Our Reference: **089243-CUR-XX-XX-T-TP-00001-P02**

Knowsley Council Planning Reference: **25/00415/REM**

Plot 3 – Land at Lowe Road, Halewood South – Transport Technical Note

This Transport Technical Note (TTN) has been prepared in response to the Knowsley Council's latest consultation response (Highways Observation Memo dated 26th January 2026) regarding the Reserved Matters submission for Plot 3.

Figure 1: Extract of Drawing No. 4152-PL-001 Rev B (App Ref: 22/00466/REM)

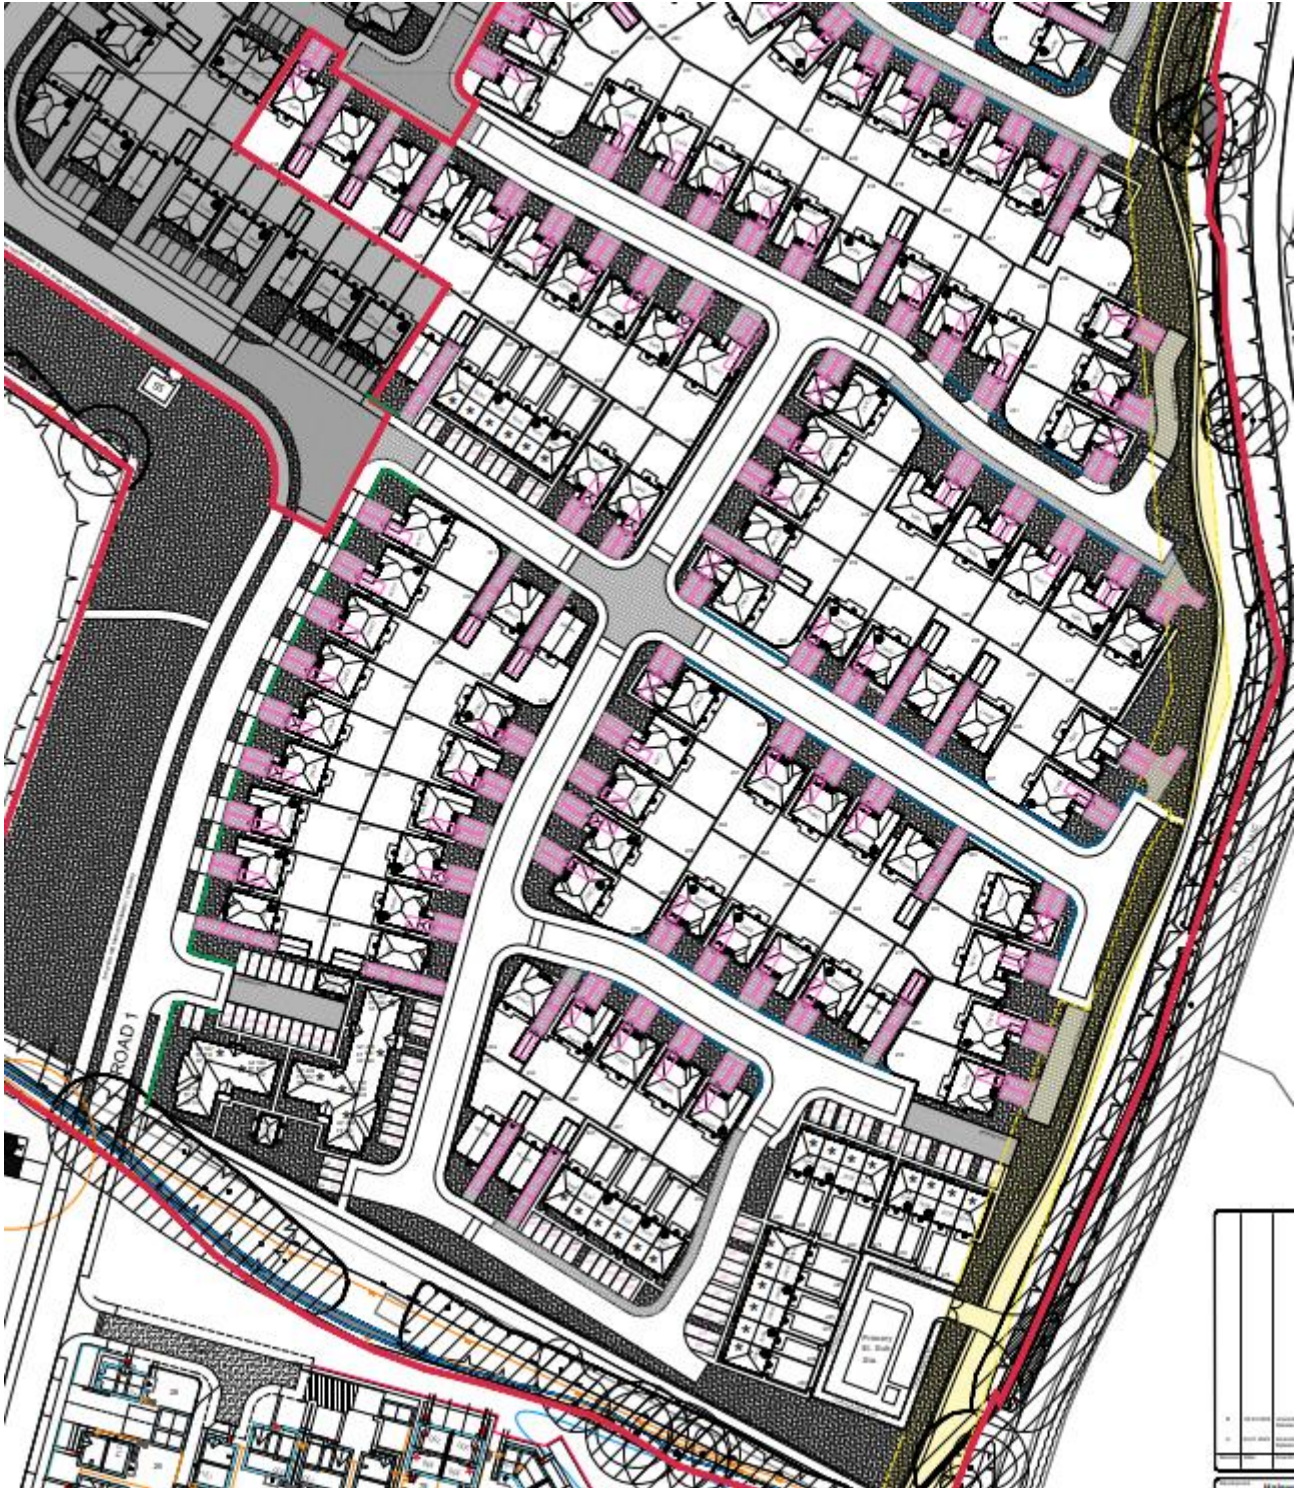
“Localised intensification within the parcel (now 123 dwellings vs 106 previously approved, approx. 16% uplift) and the resulting frontage/pedestrian environment effects.”

The specific issue raised by Knowsley Council therefore relates to the internal site layout in respect of driveway frequency, kerb continuity, pedestrian priority and the intended Masterplan street character.

It is evident from Figures 1 and 2 that the internal road layout is directly comparable with the current application maintaining the same alignment, dimensions and traffic calming features determined to be acceptable in the previous reserved matters application.

Whilst the number of parking spaces and driveways have increased in proportion with the additional 11 dwellings now proposed, the pedestrian priority remains the same as the consented scheme with an identical level of pedestrian infrastructure provided in terms of footway length and width.

The pedestrian priority is therefore considered to be consistent with the consented scheme.

In terms of driveway frequency and kerb continuity, it is acknowledged that there is a slight variation between the consented scheme and the current proposals. However, the current proposals have carefully considered the frequency of driveways as part of the overall landscape strategy and ensured each plot has a suitable landscape strip between driveways. The strategy ensures a continuous footway throughout the plot and maintains pedestrian priority. The landscaping strategy also presents an opportunity to limit the length of dropped kerbs and maintain affective street function.

It is therefore determined that the submitted proposals provide an internal layout that is consistent with the previously consented scheme and delivers adequate safe infrastructure for pedestrians.

It is evident from Figures 1 and 2 and the internal highway layout and internal junction arrangements are identical and designed to the same principles. Junction visibility of 2.4mx 25m is achievable throughout and is therefore considered acceptable.

Figure 3: Cycle Parking/Bin Store Detail

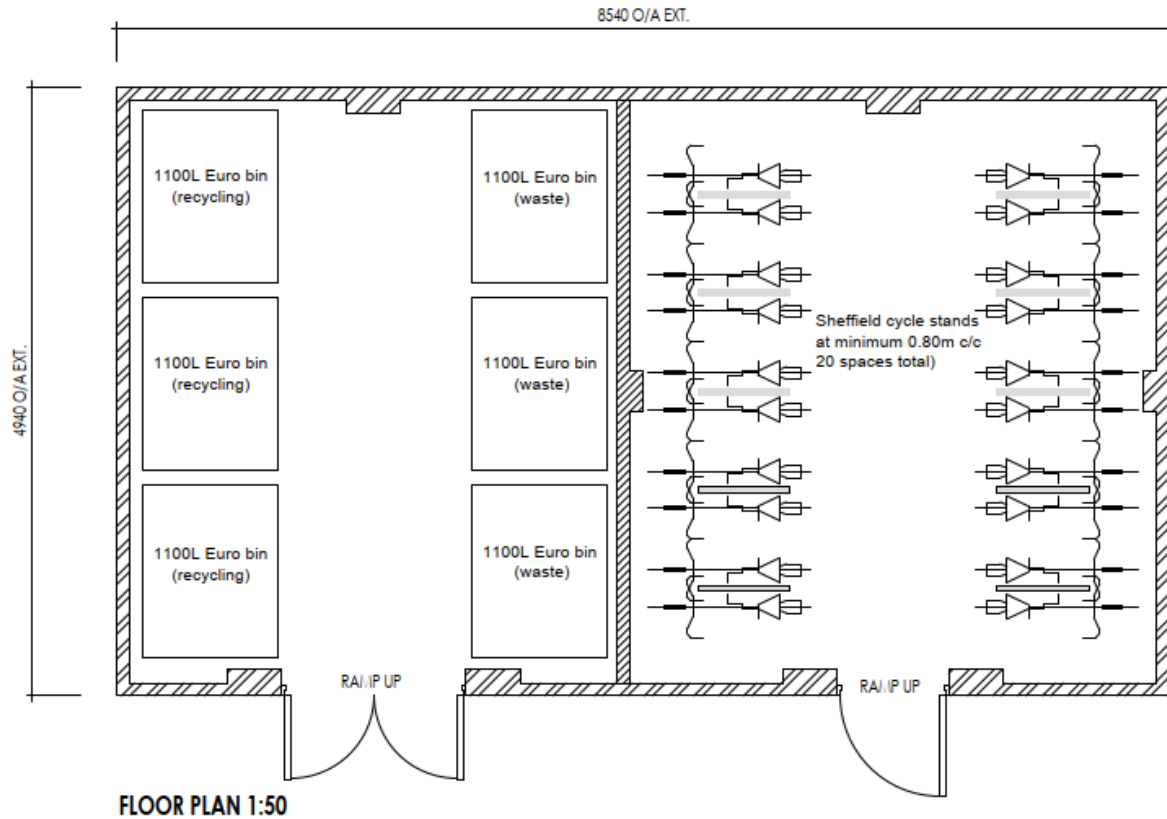
“Inadequate demonstration of apartment long-stay cycle storage capacity and usability, compounded by the bin/cycle co-location issue.”

In order to provide comfort to Knowsley Council, Figure 3 presents the typical cycle parking/bin store detail.

Figure 3 confirms that a single cycle/bin store has capacity to accommodate 20 bicycles and up to six 1,100L euro bins for waste and recycling.

The two cycle/bins stores would therefore deliver 40 cycle parking spaces to serve the 22 apartments equating to a provision of 1.8 cycle parking spaces per apartment.

It is noted that the reserved matters consent originally proposed 24 cycle parking spaces to serve the 24 apartments equating to a 1:1 provision. The current application therefore represents a net increase in cycle parking, demonstrating a further commitment to sustainable travel.
